## Application for a replacement licence

### Part V Division 3 of the *Environmental Protection Act 1986*

<b>Licence Number</b>	L8015/2003/4
<b>Applicant</b>	Mundella Foods Pty Ltd
<b>ACN</b>	055 862 774
<b>File Number</b>	2010/002296-1~2
<b>Premises</b>	Mundella Foods Lot 2 on Plan 51860 (Randell Road), Lot 51 on Plan 226010, Lot 52 on Plan 226115, Lot 123 on Diagram 5045 and Lot 522 on Plan 249485 MARDELLA WA 6125  As defined by the premises maps attached to the issued licence
<b>Date of Report</b>	6 July 2021
<b>Proposed Decision</b>	Licence granted

**Figure 4: Nutrient loading rates and current licence limits**

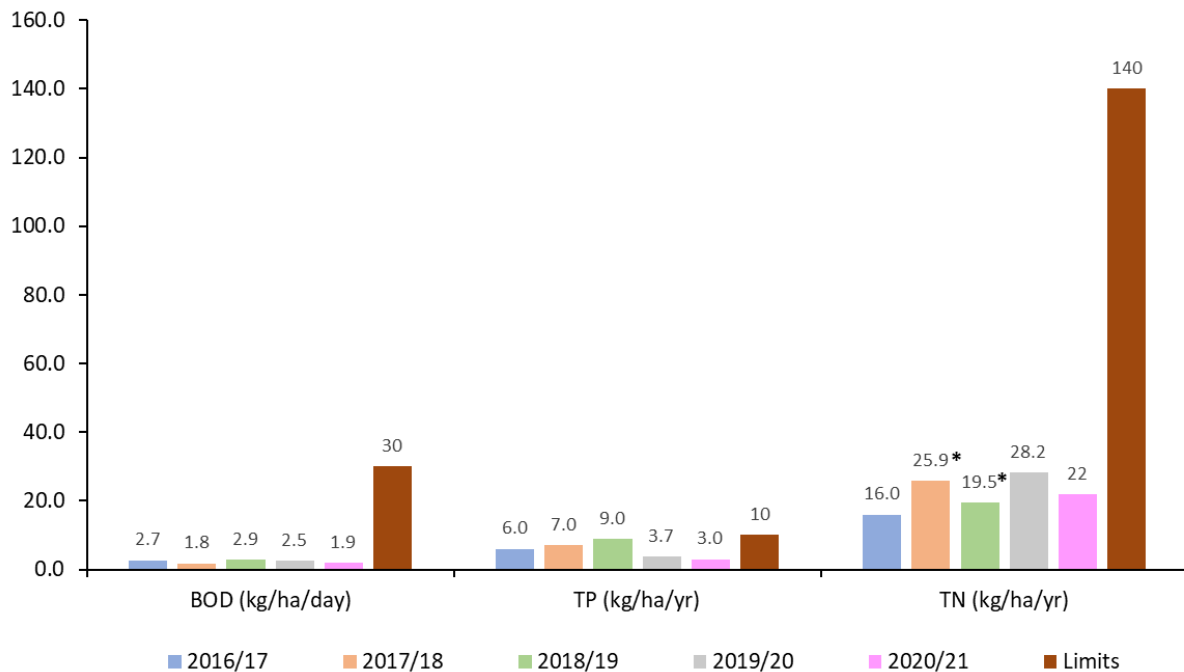
The AERs that have been submitted for the reporting periods 2016 - 2019 state that irrigation has occurred on 146.5 ha of land in each reporting period. The Nutrient Irrigation Management Plan (NIMP) that was submitted with the application reports on more recent data, from 2019/20. This states that irrigation only occurred on 79.4 ha for the year. Of the above parameters to be monitored, the existing licence only stipulates limits on TN, TP and BOD. A review of the most recent AERs has determined that the licence holder has been within these limits (Figure 4) (data is averaged over the data collection period).

The phosphorous loading limit on the existing licence is 10 kg/ha/yr, and a review of the last three reporting periods demonstrates that the licence holder has stayed within this limit. However, as discussed above, the current phosphorus application rate to land in the irrigation area is not sustainable. Therefore, an increase in the level of treatment of the wastewater is required to lower the phosphorous concentrations to below 30 mg/L content prior to irrigation.

**Figure 5: DWER recommended locations of monitoring bores.**

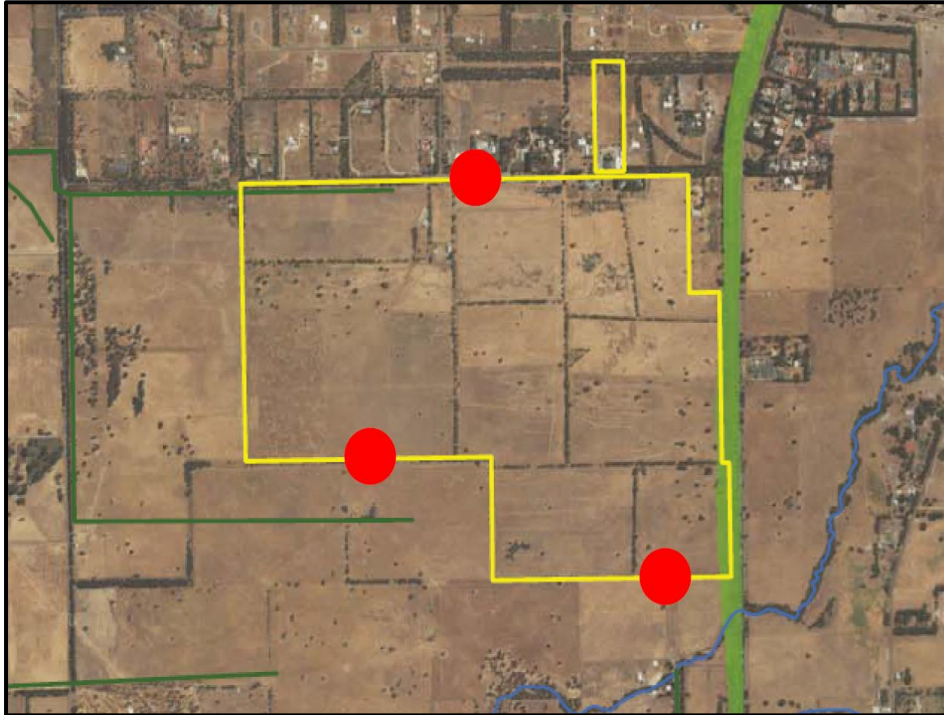
There is currently no requirement to monitor groundwater at the premises under the existing licence. Due to the size of the Mundella wastewater irrigation scheme and the high-strength

characteristics of the wastewater, it is recommended that monitoring bores are installed at the site. It is recommended that a minimum of three shallow bores with six metre length screened intervals are installed in the approximate locations shown in Figure 5. This arrangement of bores will allow the groundwater flow direction to be accurately determined. It will also allow a direct comparison to be made between the quality of groundwater that enters the irrigation area from the north to the quality of groundwater that flows from the southern boundary of the area to quantify the effect of irrigation on the groundwater quality.
